# SAN FRANCISCO PLANNING DEPARTMENT

## Discretionary Review Abbreviated Analysis

*Date:* June 18, 2015  
*Case No.:* 2014-003161DRP  
*Project Address:* 2331 19<sup>TH</sup> STREET  
*Permit Application:* 2014.05.22.6466  
*Zoning:* RH-2 (Residential House, Two-Family) Zoning District  
40-X Height and Bulk District  
*Block/Lot:* 4076/017  
*Project Sponsor:* Karin Payson  
17 Jack Kerouac Alley  
San Francisco, CA 94133  
*Staff Contact:* Richard Sucre – (415) 575-9108  
[Richard.Sucre@sfgov.org](mailto:Richard.Sucre@sfgov.org)  
*Recommendation:* **Do Not Take DR & Approve the Project As Proposed.**

Discretionary Review Hearing  
Case Number 2014-003161DRP  
2331 19<sup>th</sup> Street

Drawing Title  
**WEST ELEVATION**

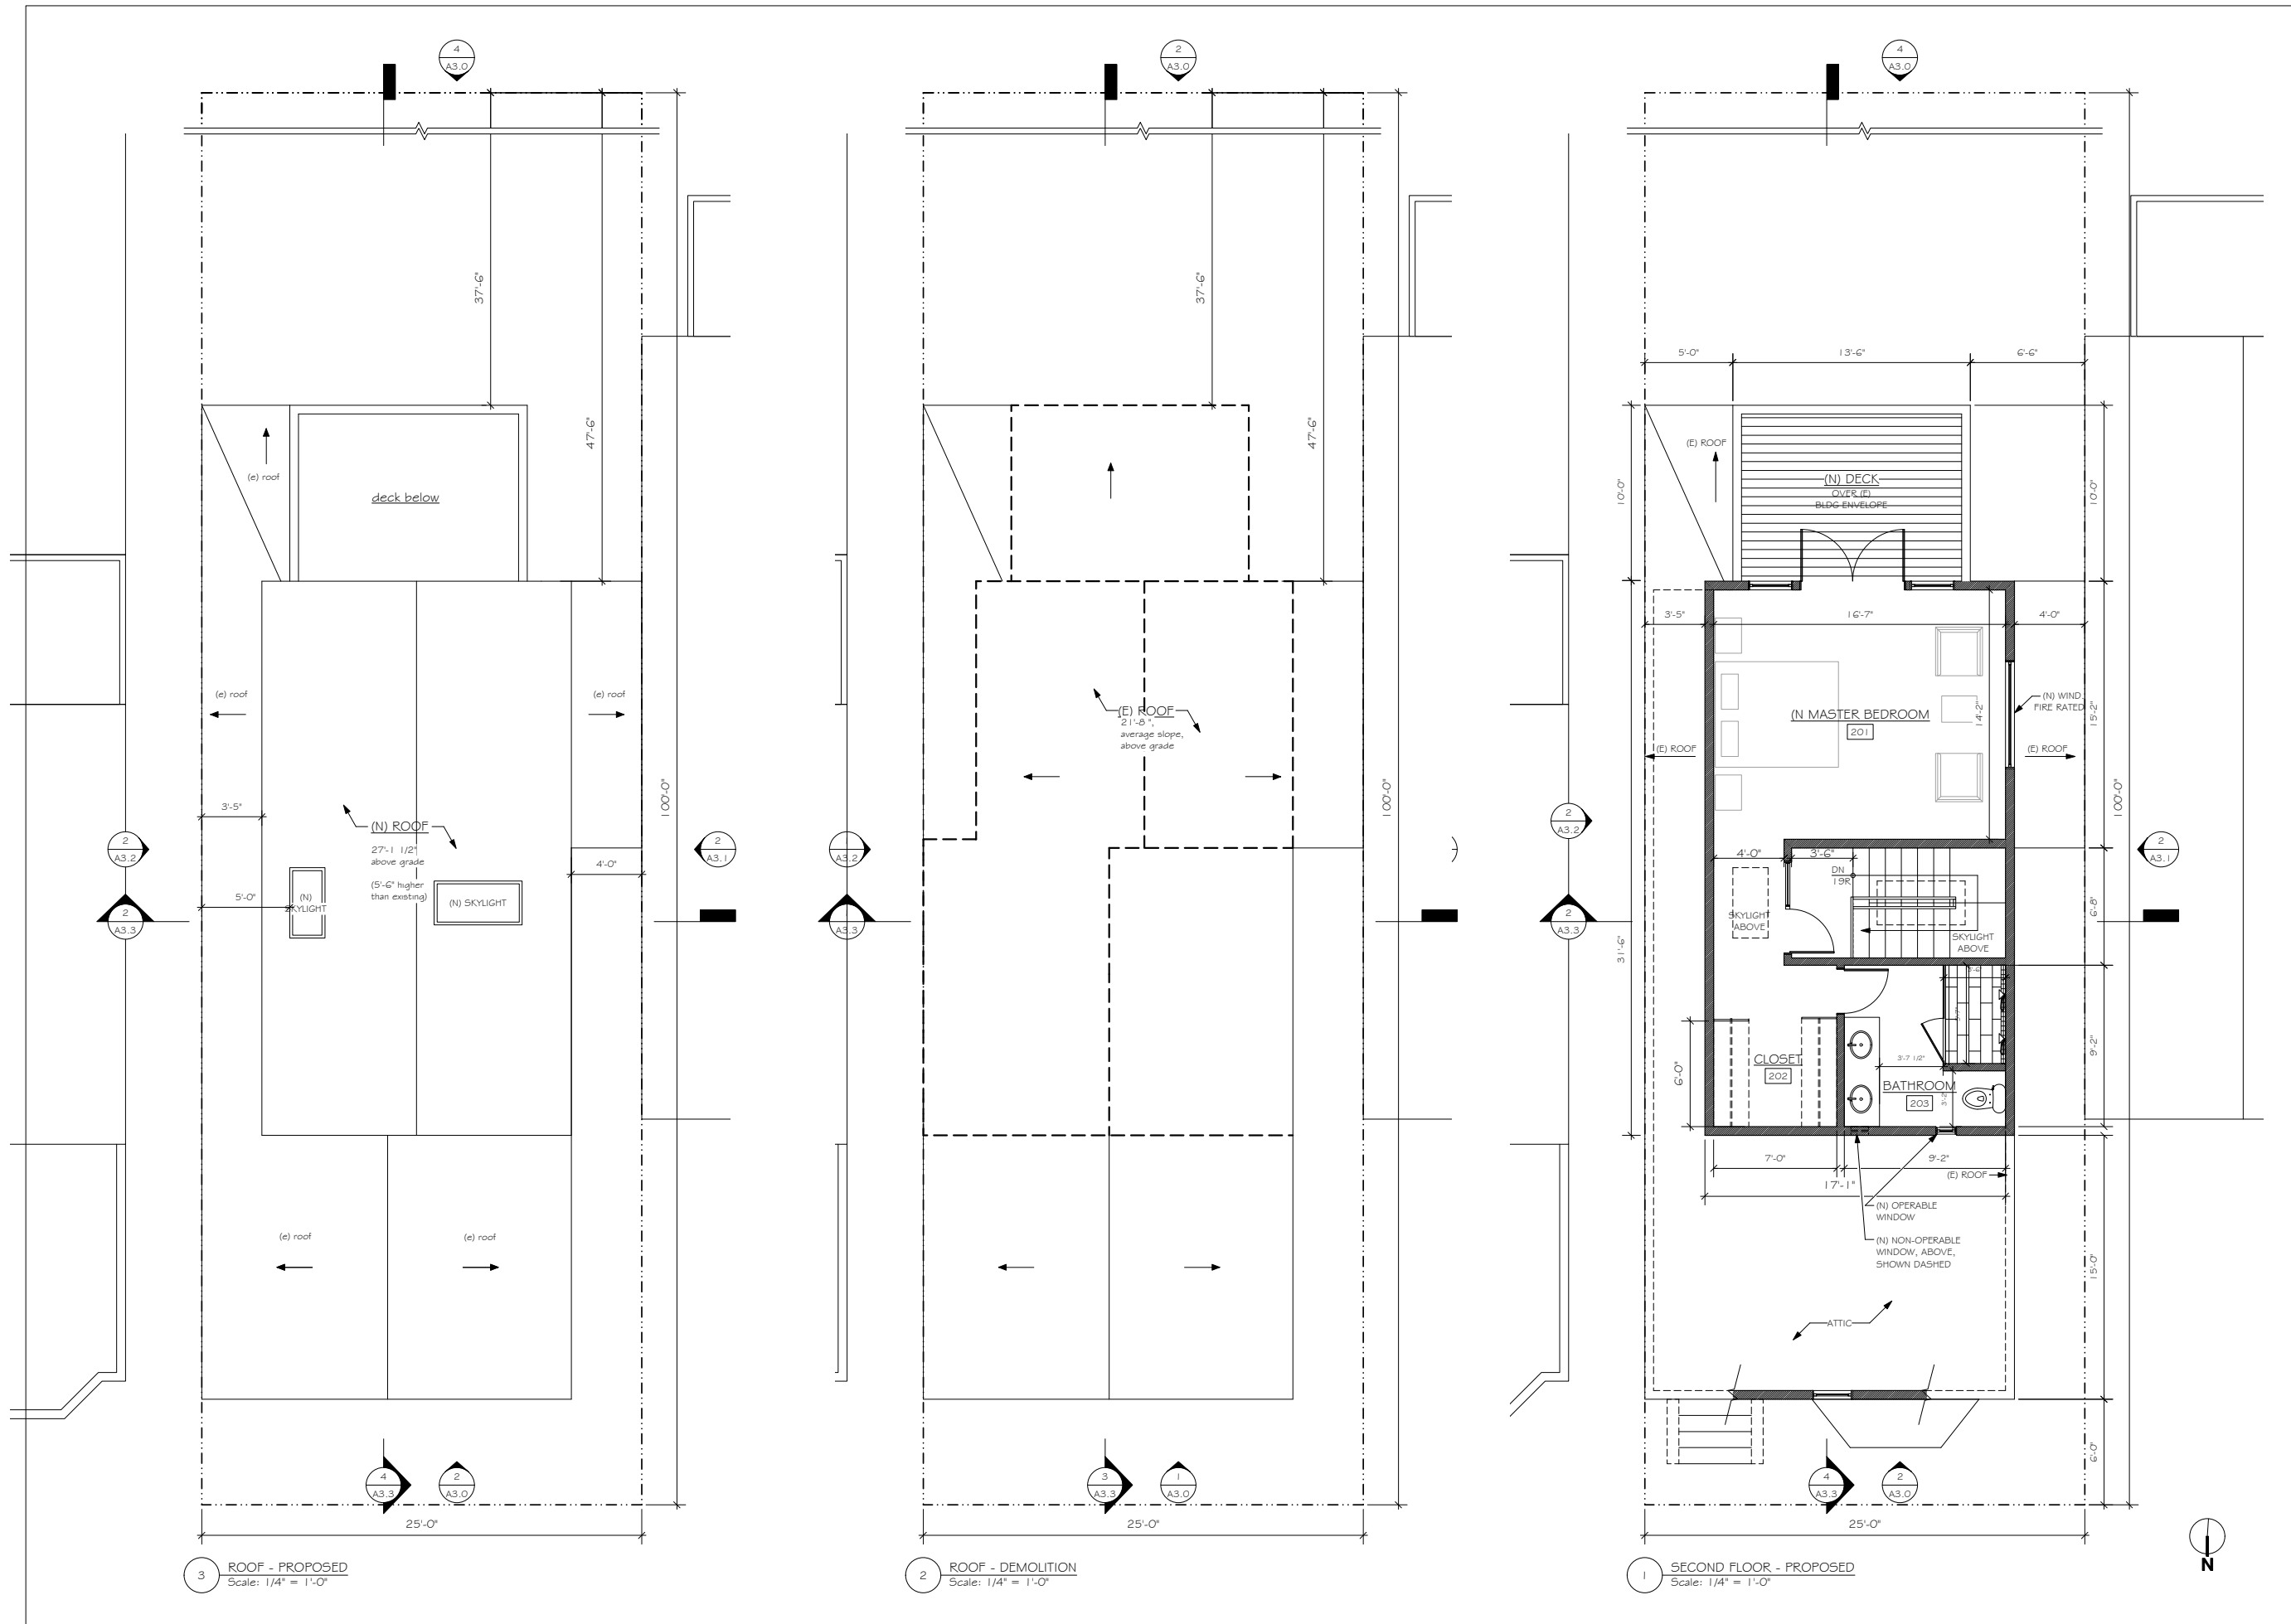
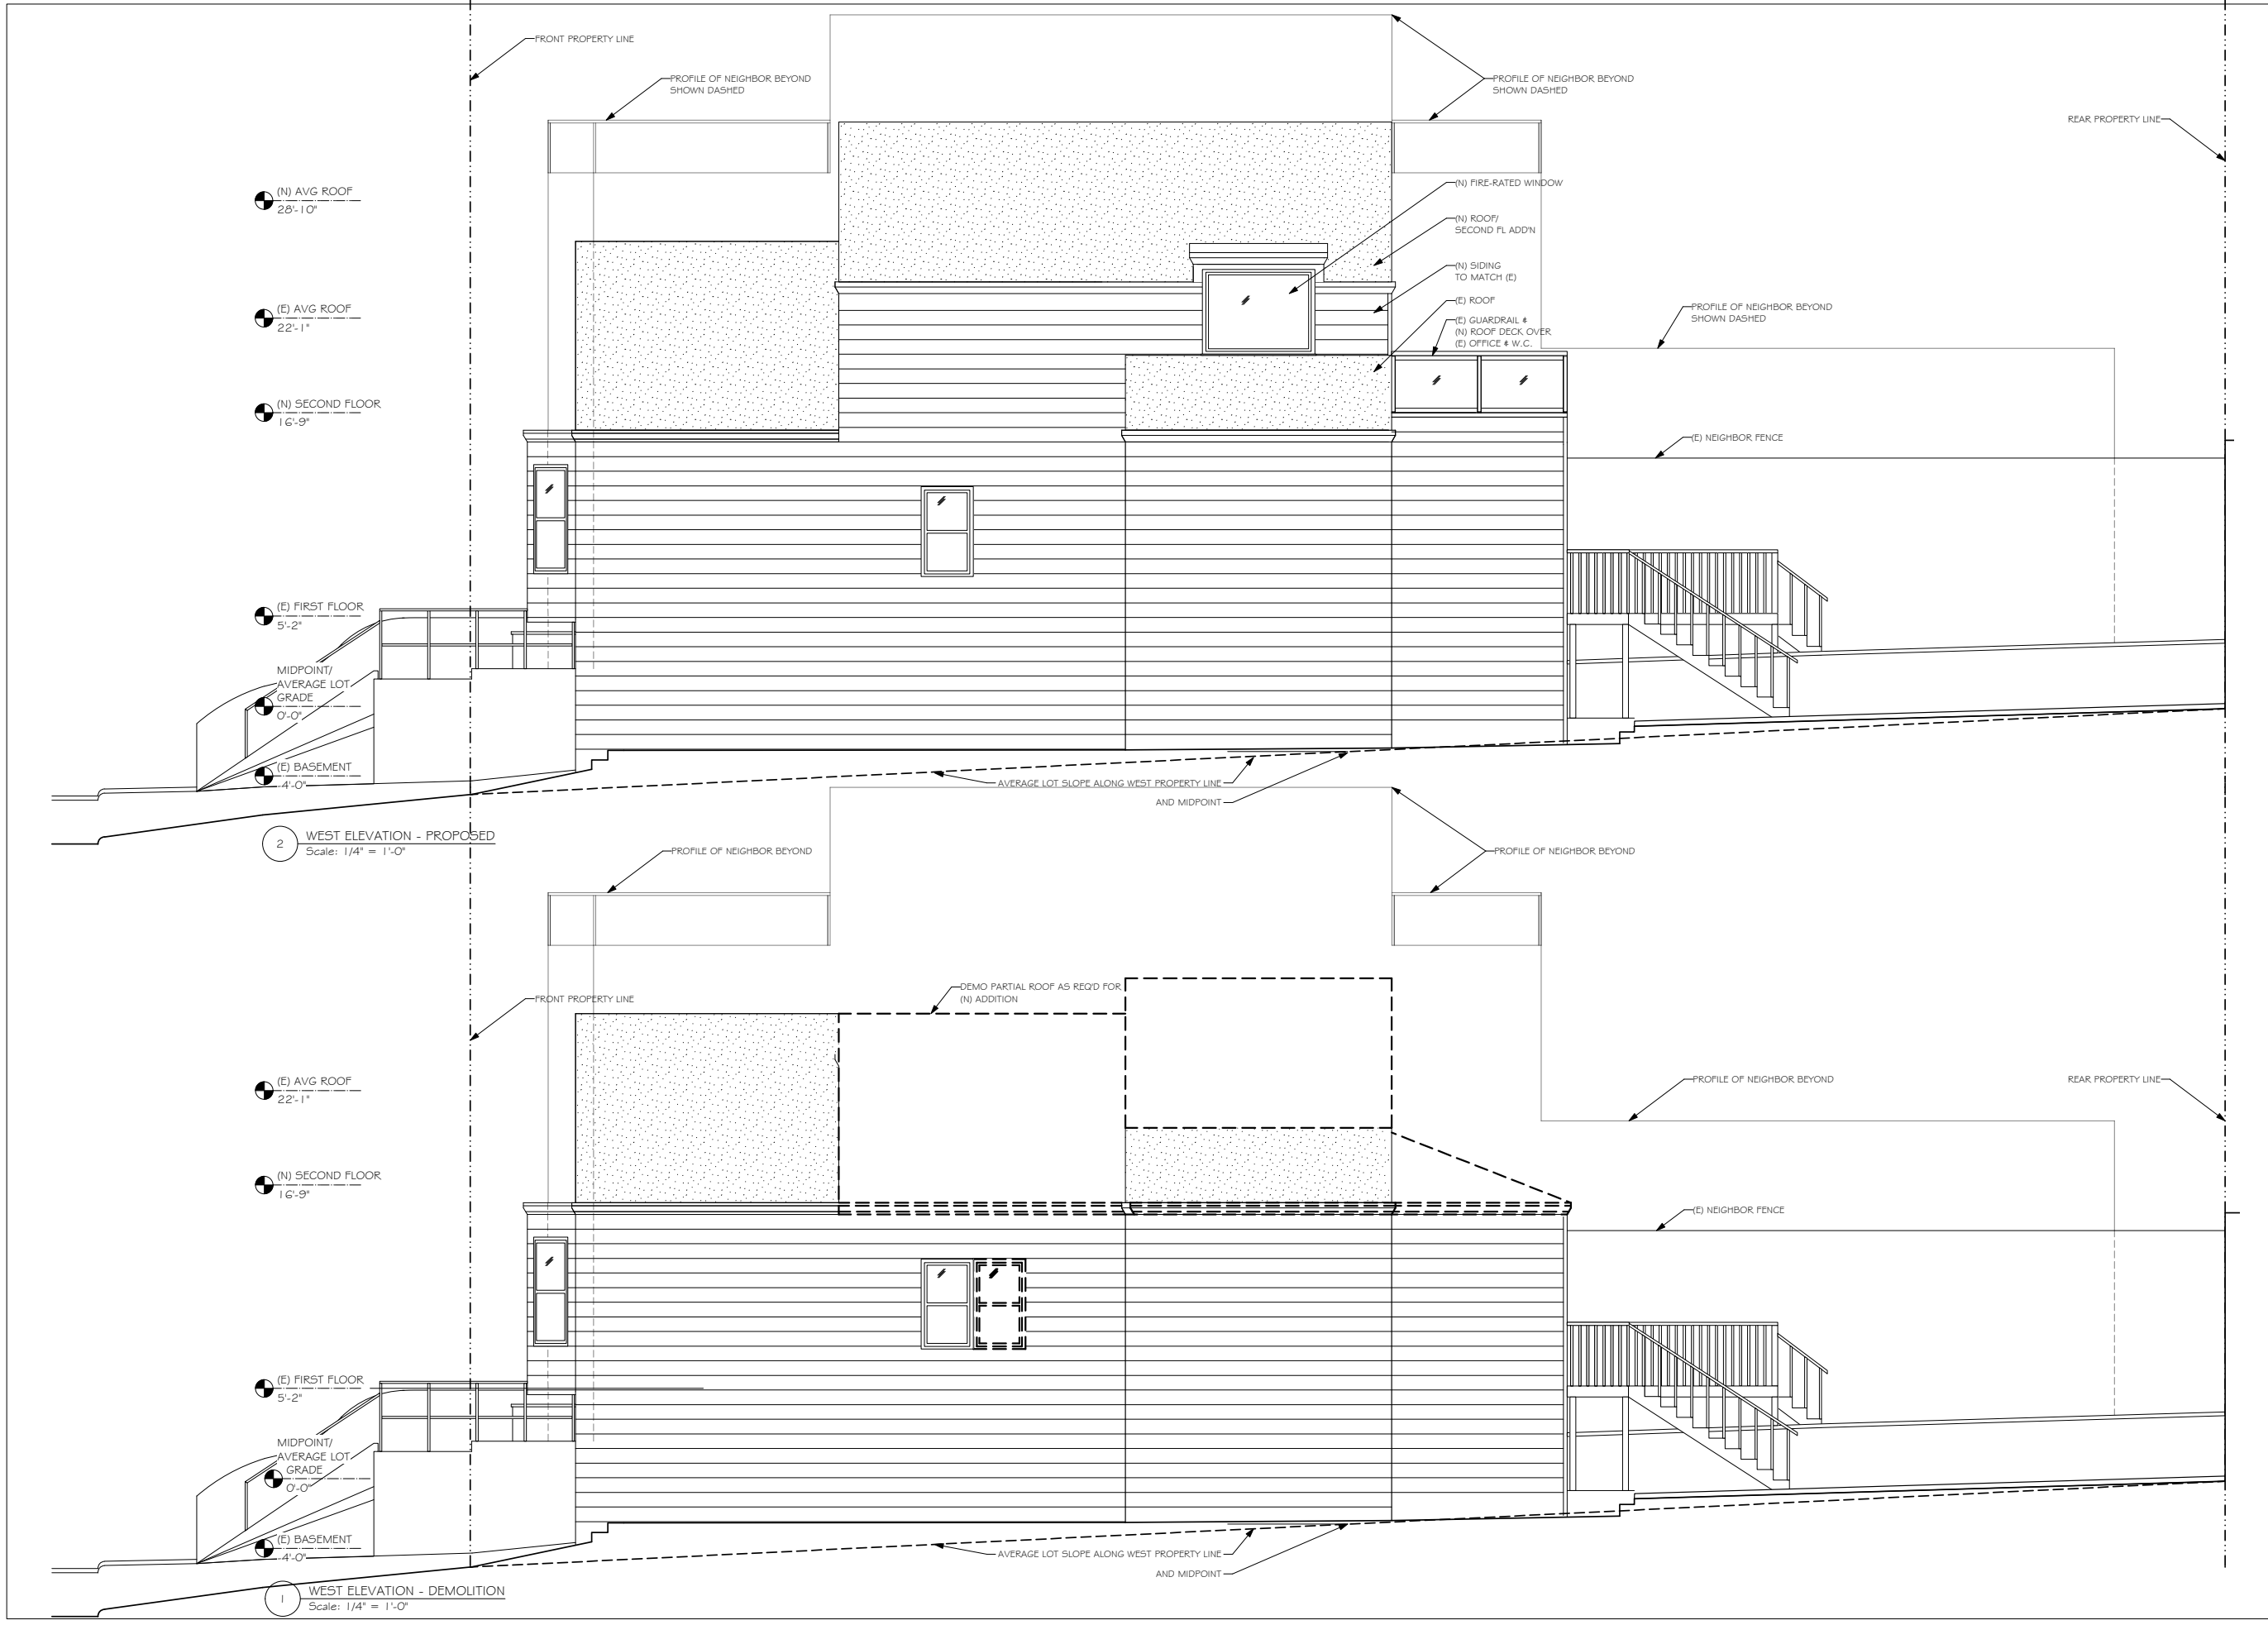
The relationship of the elevation of Project Sponsors' floors and roof height to those of Applicants are not precisely known. Project Sponsors' architect prepared drawings based on estimated elevations of Applicants' floors and roof. Applicants have since offered to provide elevation measurements prepared by Applicants' architect. As such, Applicants are concerned about what the actual impact will be. Additionally, during a site inspection, Applicants' agents noted that the drawings misrepresented certain windows on the project's eastern wall. Such inaccuracies may impact Applicants' privacy.

In response to the complaint that the relationship of the two buildings is inaccurately represented in the drawings, KPa+d has corrected the drawings to the best of its ability lacking a formal survey. These revised drawings have been submitted to Planning.

Photo 1: Project Sponsor roof (existing) from Applicants' kitchen. Proposed location of roof deck. Note arched roofs.

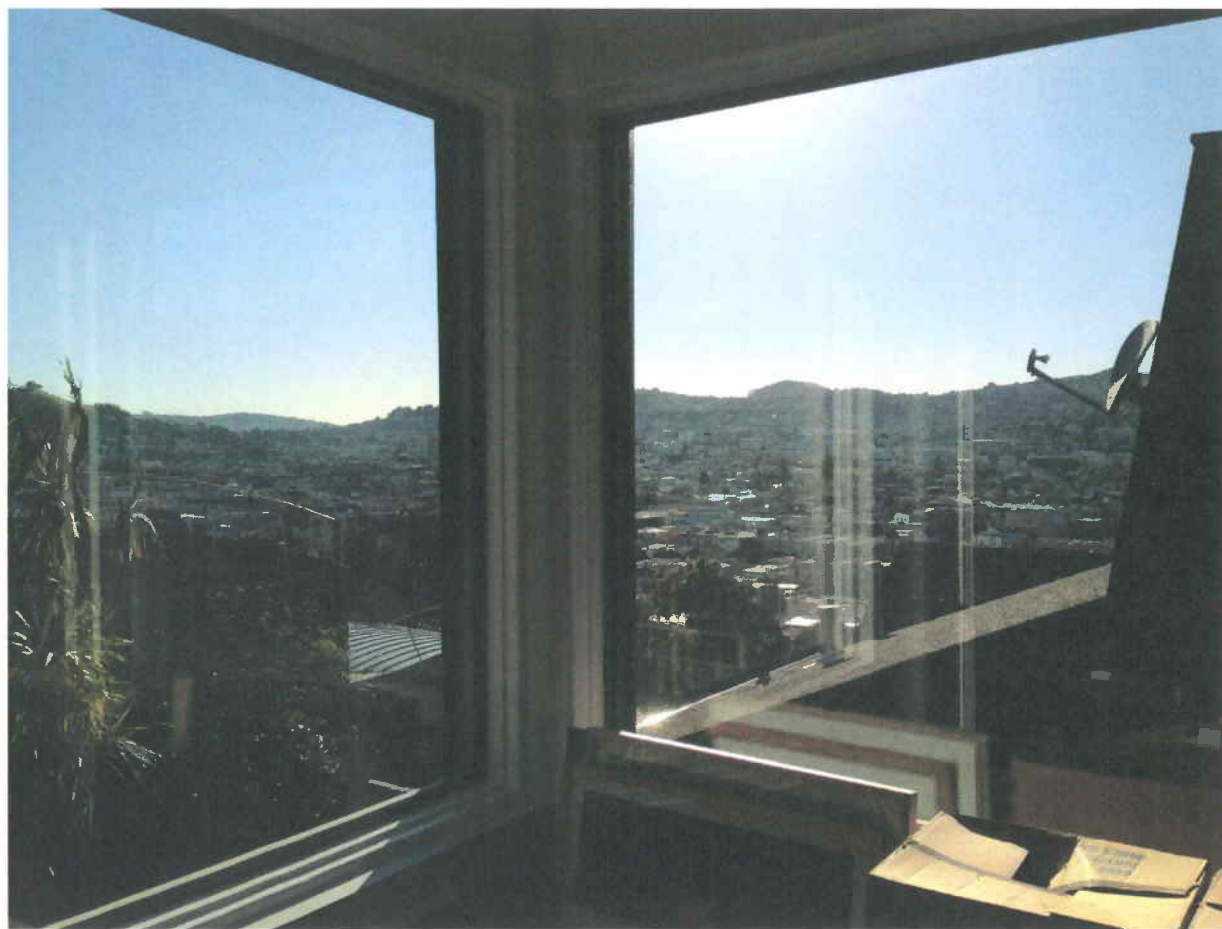
A unique characteristic of Applicants' and 2321 19<sup>th</sup> Street's properties is that they share a unique roof characteristic. Each of them has an arched roofline. This creates an interesting visual feature as opposed to standard flat roofs of peaked roofs with roofing tiles. Applicants have proposed that Project Sponsor use a similar roofline on its addition. This would enhance the roofline features on the existing buildings and help unite the shared mid-block open space. A drawing is attached as "Exhibit A" to this addendum. See Exhibit B photo 1 (arched roofs)

Further, the proposed project would limit privacy at the rear of the properties, where the Project Sponsors' proposed roof deck would be very close to the Applicants' kitchen. See Exhibit B – photos 2 and 3.

In response to the complaint that the project will "have a negative impact on Applicants'...privacy" we have offered to build a 6'-0" high privacy wall at the deck where it faces the property line. The DR applicant rejected that option and instead requested that we have a glass guardrail at that location, which we have agreed to do. The elevations submitted to Planning already indicate a glass guardrail facing the shared property line.
